NUMBER: 21-016-05

GROUP: Transmission

DATE: September 01, 2005

RFE Transmission - Delayed Engagement After An Extended Off Period

Fig. 2 Transmission Filters - 4X4 Shown

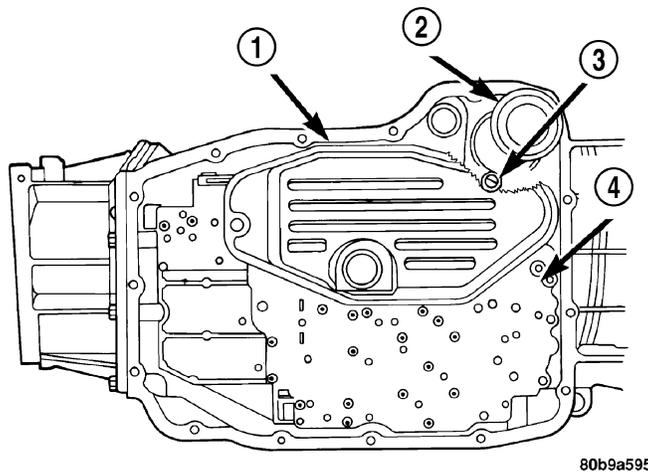
NOTE: DO NOT use a replacement cooler return filter with a part number of 04799662AB. This filter is suspect of causing the above condition. The filter part number is stenciled on the side of the filter case.

NOTE: All cooler return filters with the “AB” suffix (04799662AB) are suspect. The above condition may be corrected by replacing a suspect “AB” filter with a new cooler return filter whose part number is 04799662 (with no suffix or with a suffix that is other than the “AB” level).

NOTE: A replacement 04799662 cooler return filter may come packaged with a separate threaded adapter stud. The threaded adapter stud is used to attach the cooler return filter to the transmission. Inspect the stud and note end without threads. Install the stud end without the threads into the cooler return filter and tighten the stud-to-filter connection to 18.6 Nm (165 in. lbs.). Once the threaded adapter stud has been installed to the cooler return filter, install the assembled cooler return filter to the transmission and tighten the filter to 14.1 Nm (125 in. lbs.)

Use the procedures outlined in TechCONNECT® (Service Information Tab / 21 - Transmission Transaxle / Automatic - 45RFE 545RFE / Fluid / Standard Procedure / Fluid and Filter Replacement) to replace the cooler return filter.
